DRAINAGE AND TRANSPORTATION INFORMATION SHEET (REV 6/2018)

Project Title: NM Sol **Building Permit #:** _____ **Hydrology File #:** _____
DRB#: _____ **EPC#:** _____ **Work Order#:** _____
Legal Description: Lot 2-B, Tract S-1, Atrisco Business Park, Unit 2, City of Albuquerque, Bernalillo County, NM
City Address: 7401 Los Volcanes NW

Re: NM Sol/ Phase 1 Tenant Addition
7402 Los Volcanes Rd. NW
Traffic Circulation Layout
Architect's Stamp 03-28-23 (J10-D027)

The following are our responses to your comments on the above TCL.

A1 Architectural Site Plan / Traffic Control Layout

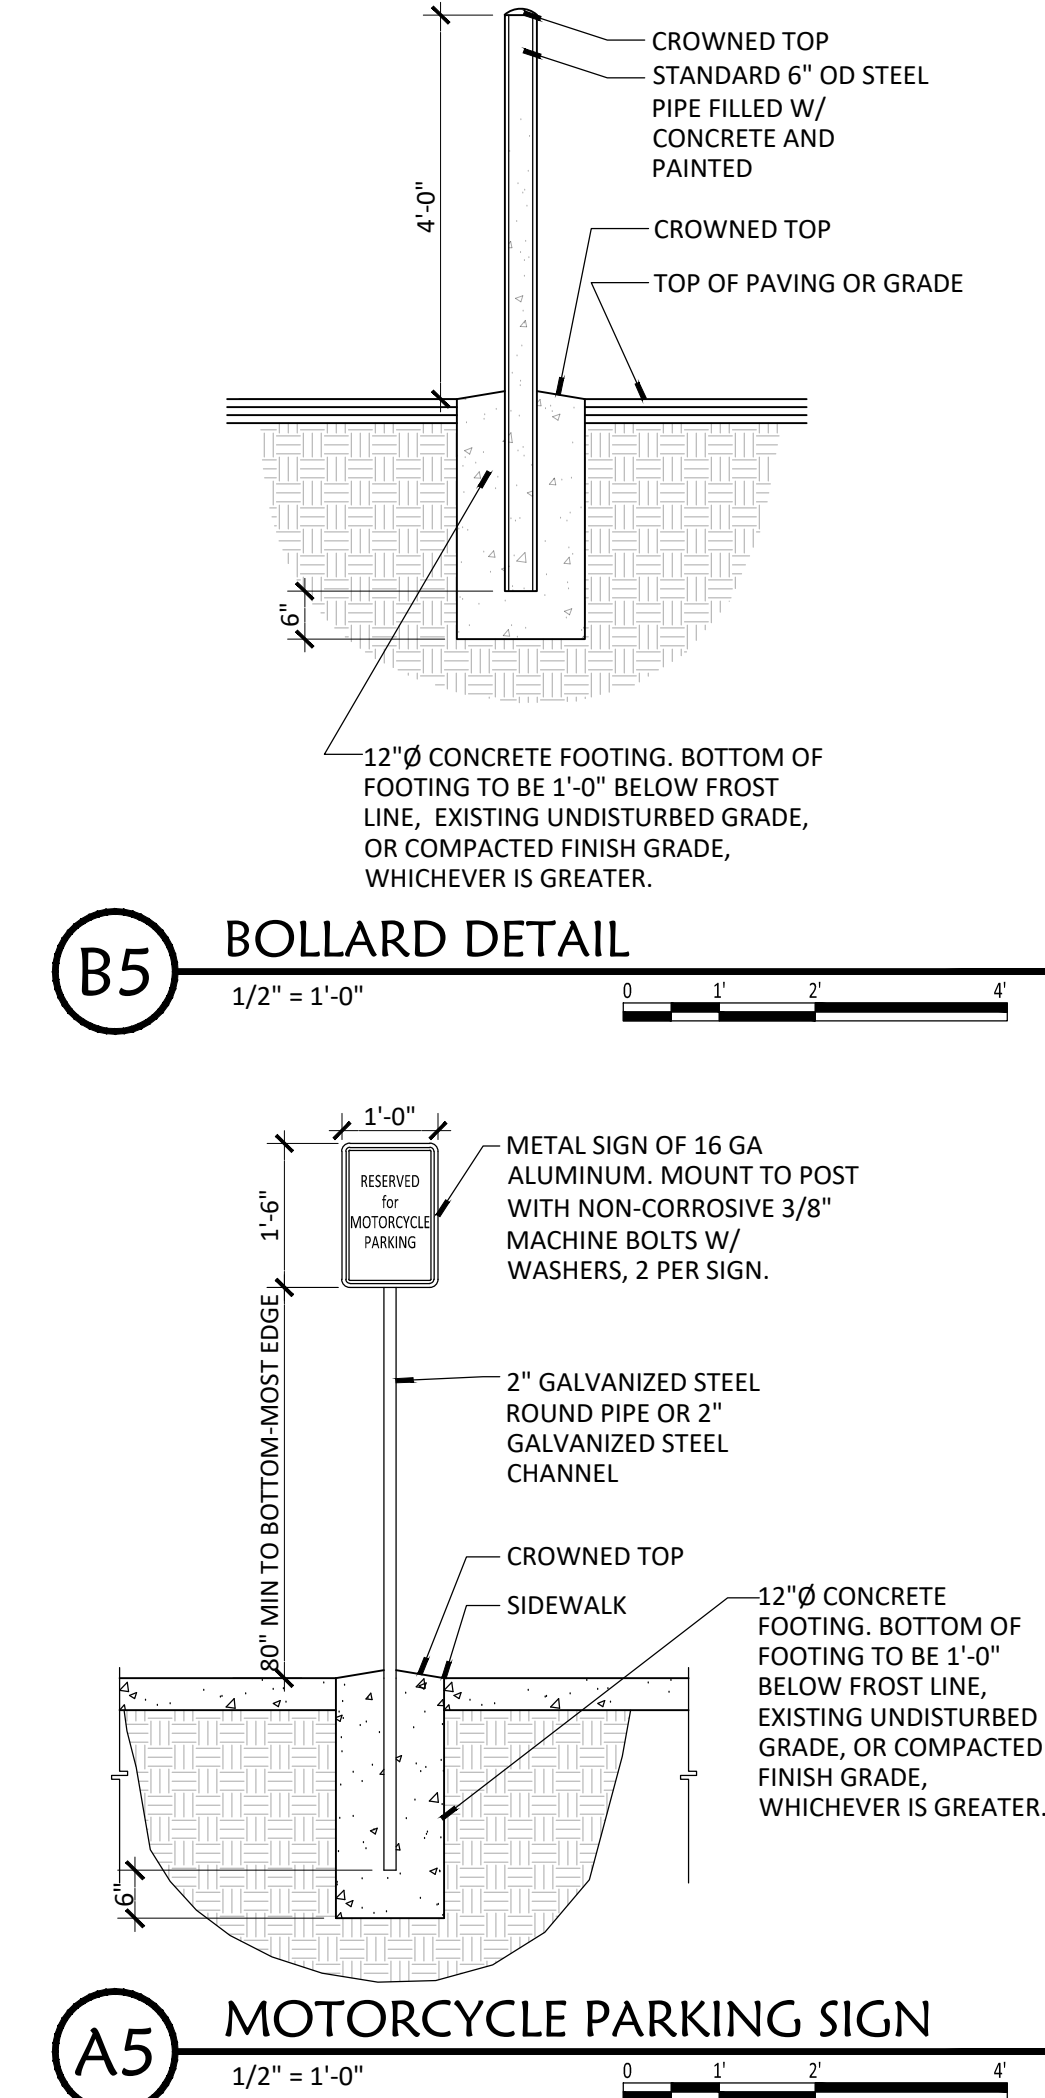
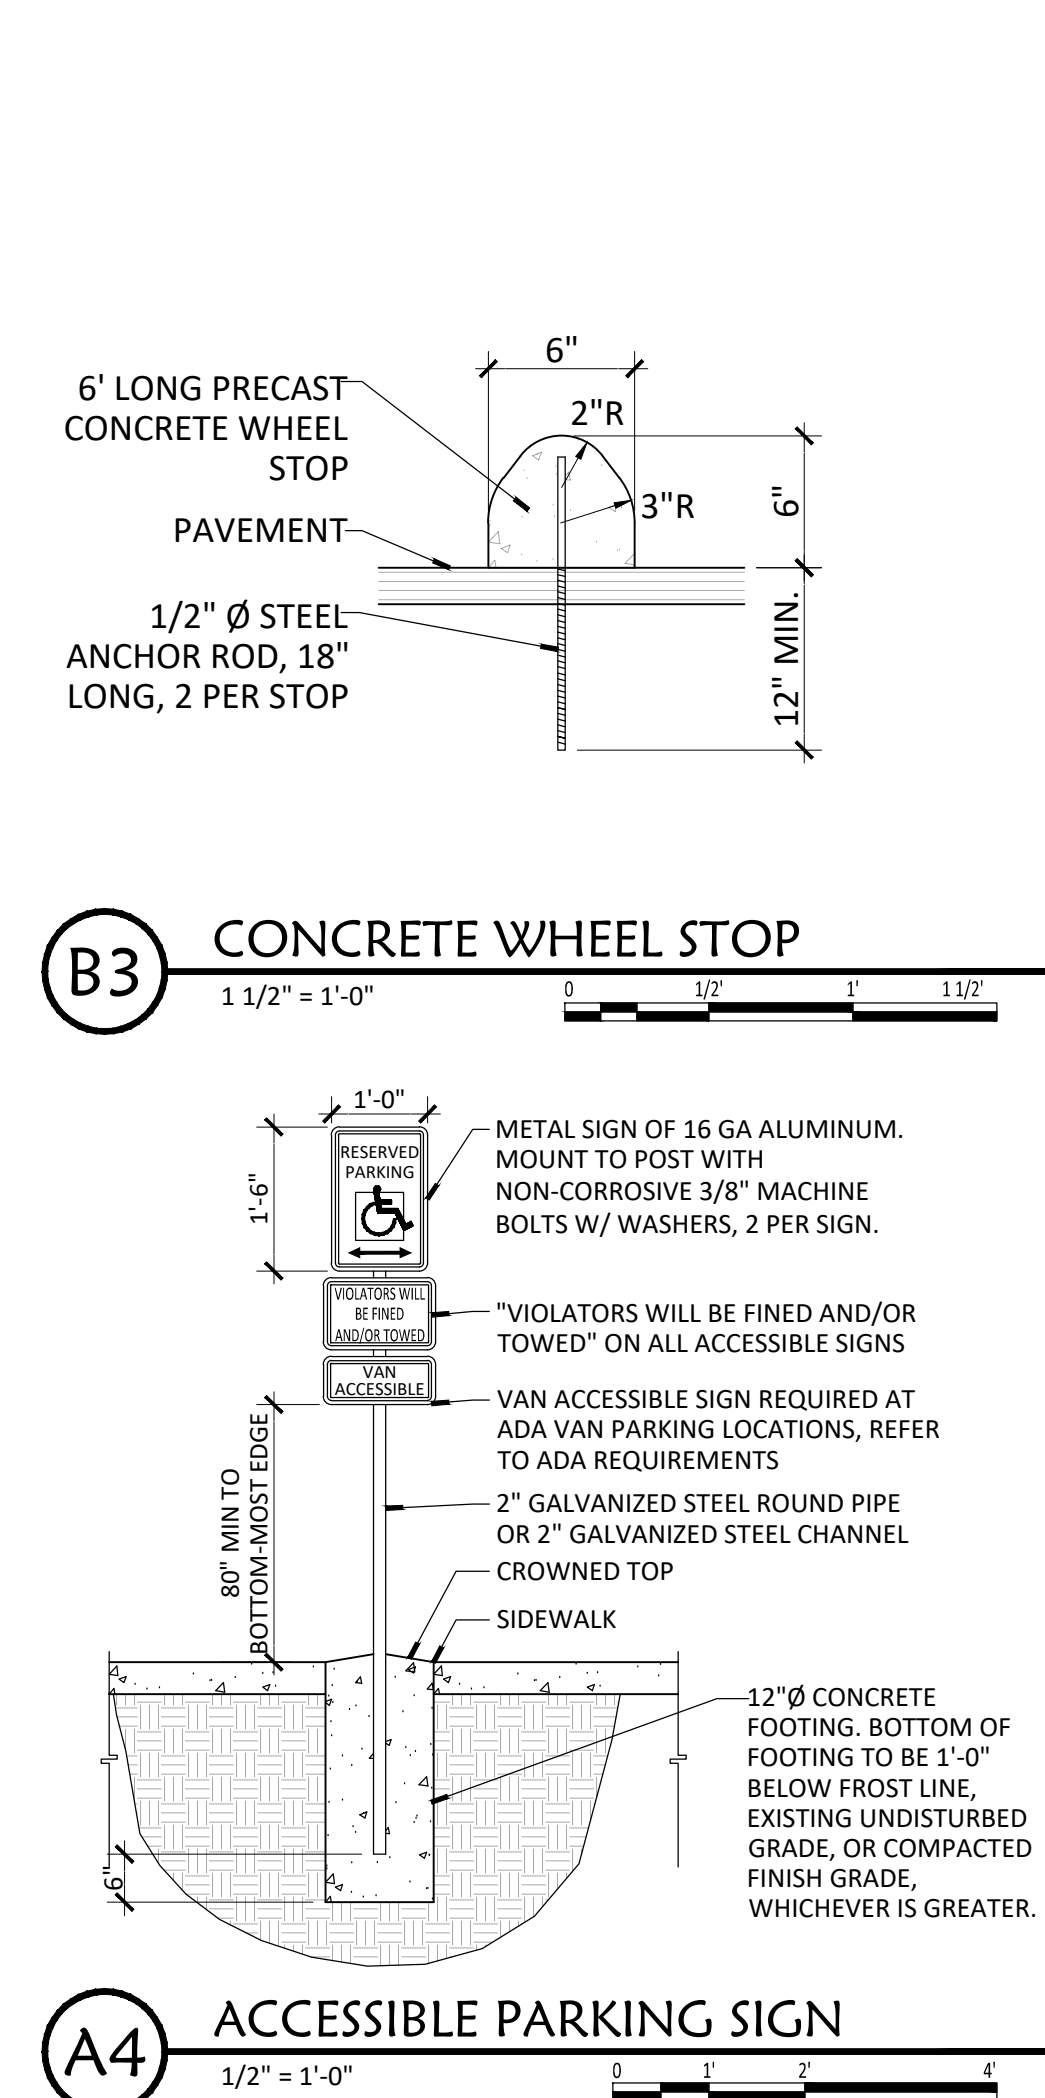
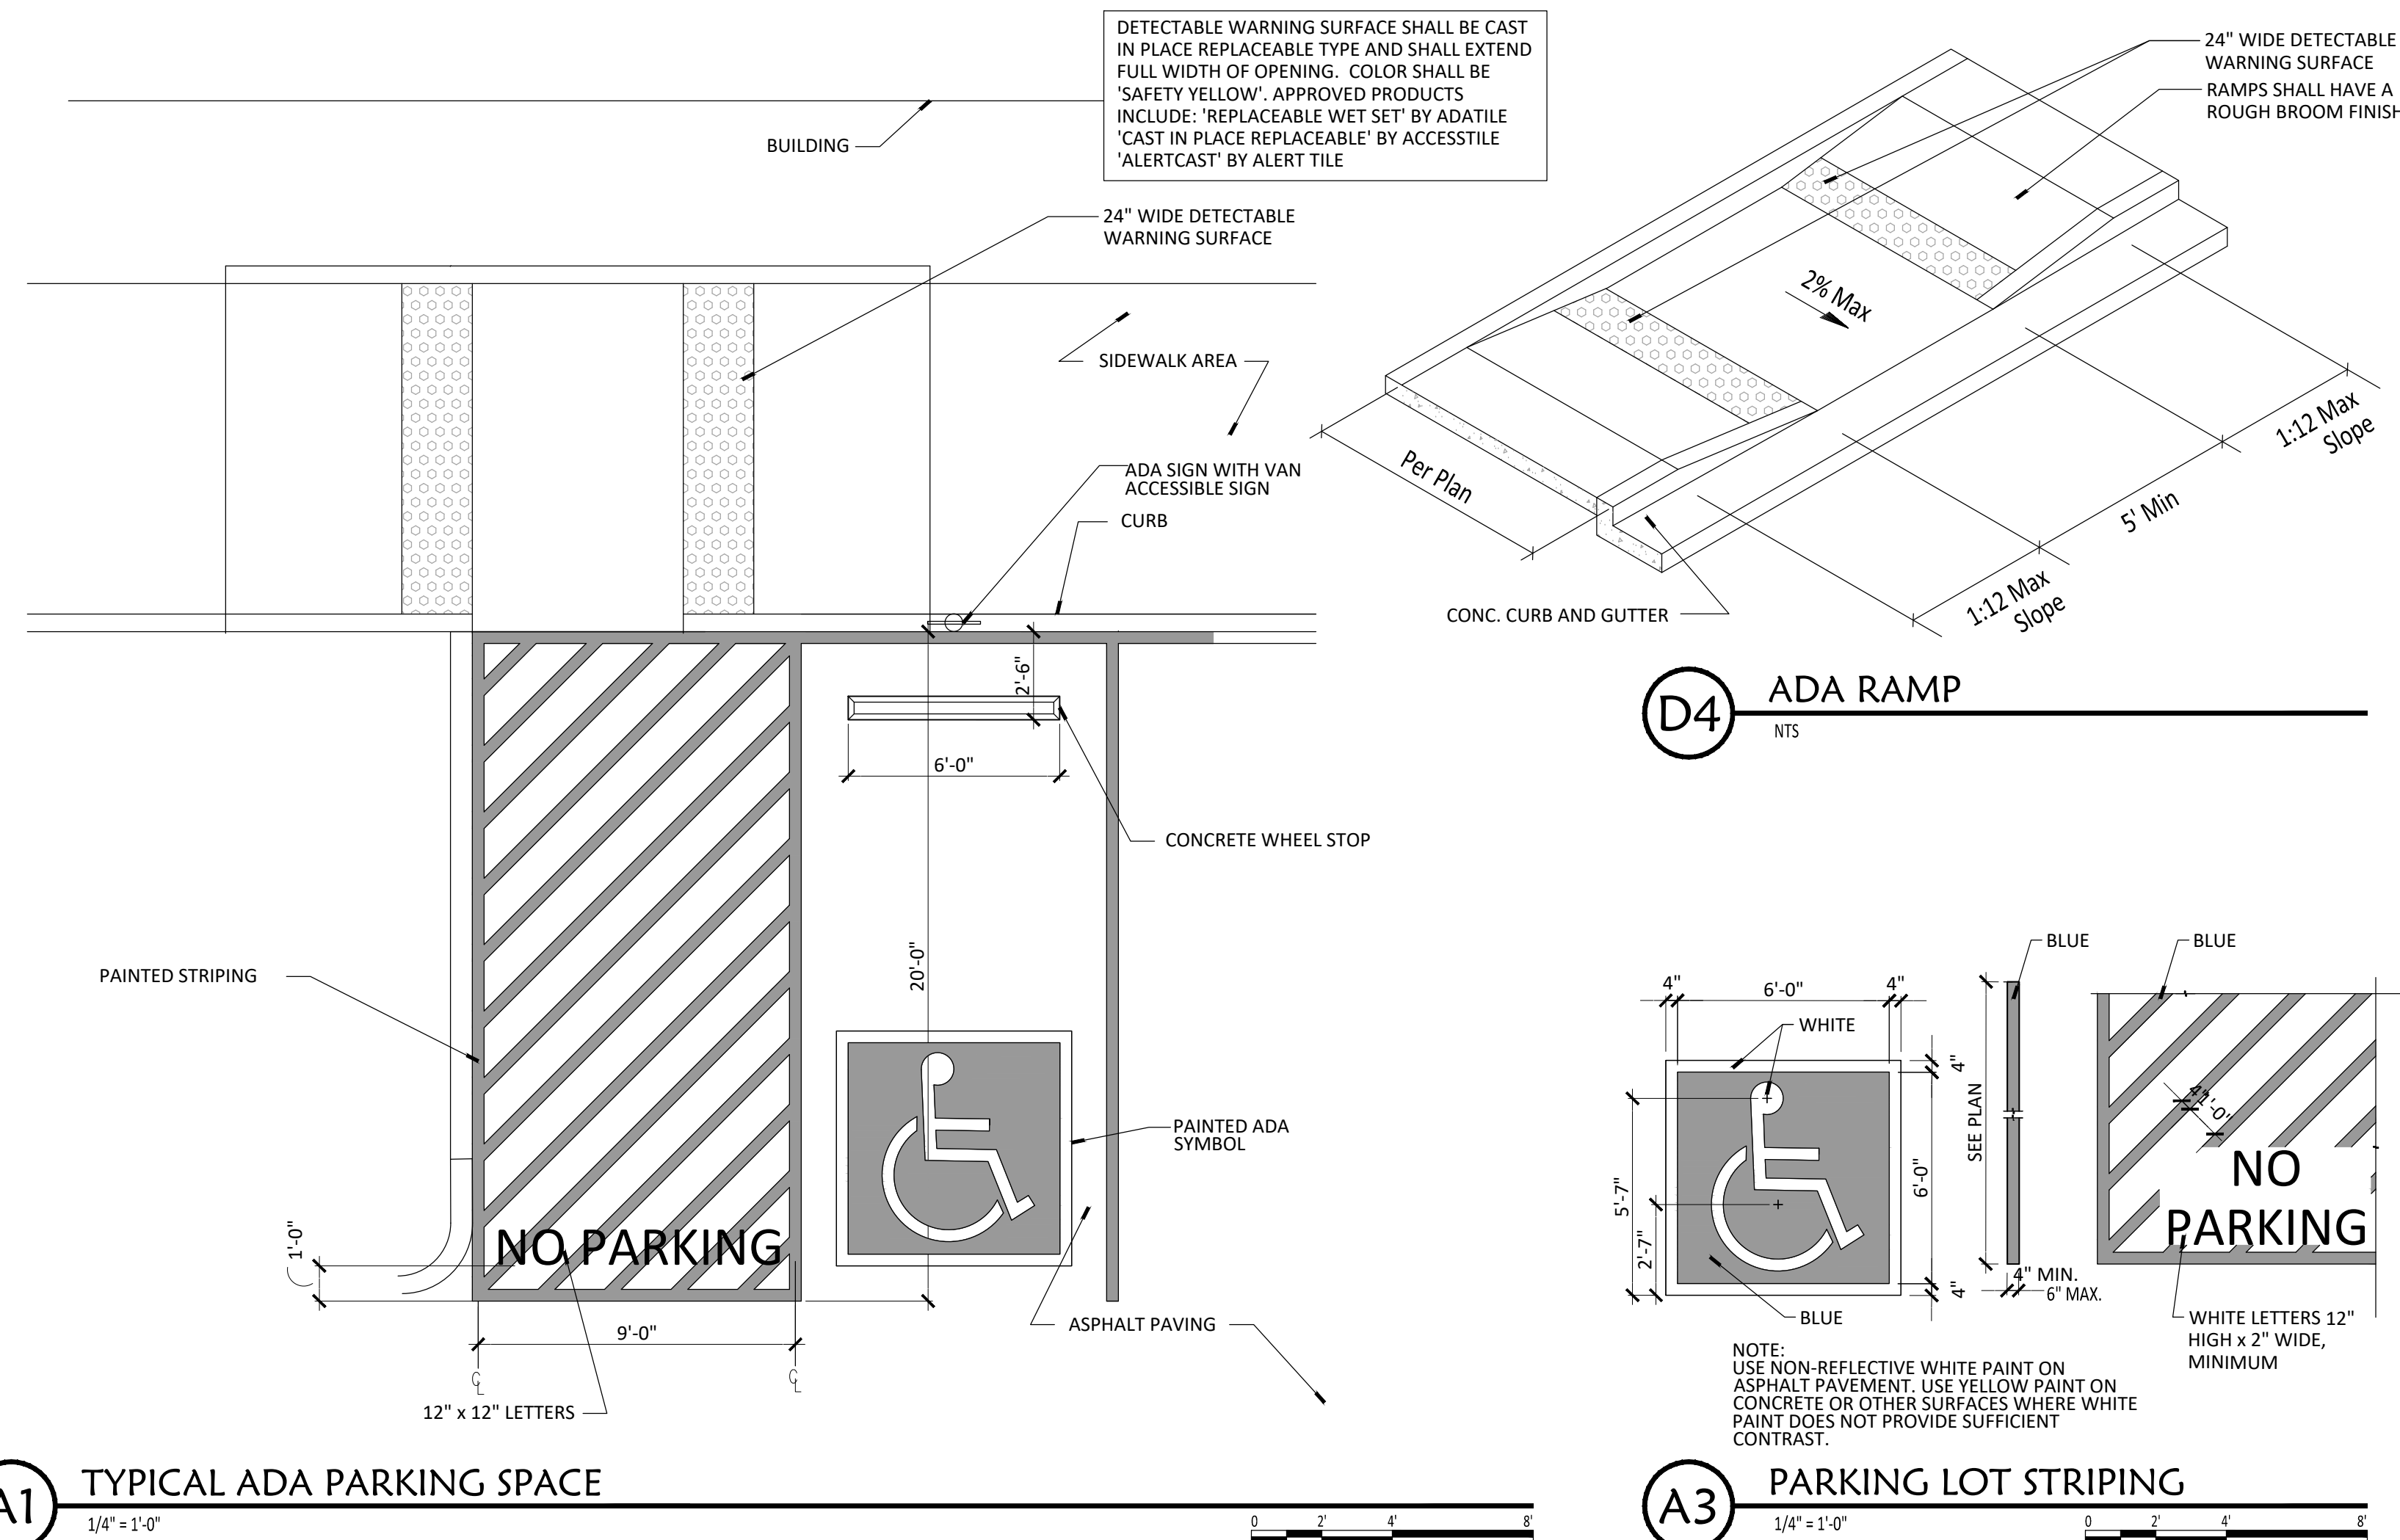
- a. Review AS101 and AS102
6. Per the IDO, a 6 ft. wide ADA accessible pedestrian pathway is required from the public sidewalk to the building entrances. Please clearly show this pathway and provide details.
 - a. Pathway updated, see AS101
7. Per DPM, a 6 ft. wide ADA accessible pedestrian pathway is required from the ADA parking stall access aisles to the building entrances. Please clearly show this pathway and provide details.

- a. Access shown, refer to AS101, AS102
- 8. ADA accessible pedestrian pathway should not be placed behind parking space or adjacent to a vehicular way. Vehicle and pedestrian/wheel chair conflicts should be avoided as much as possible.

- a. Refer to AS102
- 9. Curbing should be installed to delineate landscape, parking, and pedestrian ways and identify points of access. Please call out detail and location of barrier curb.
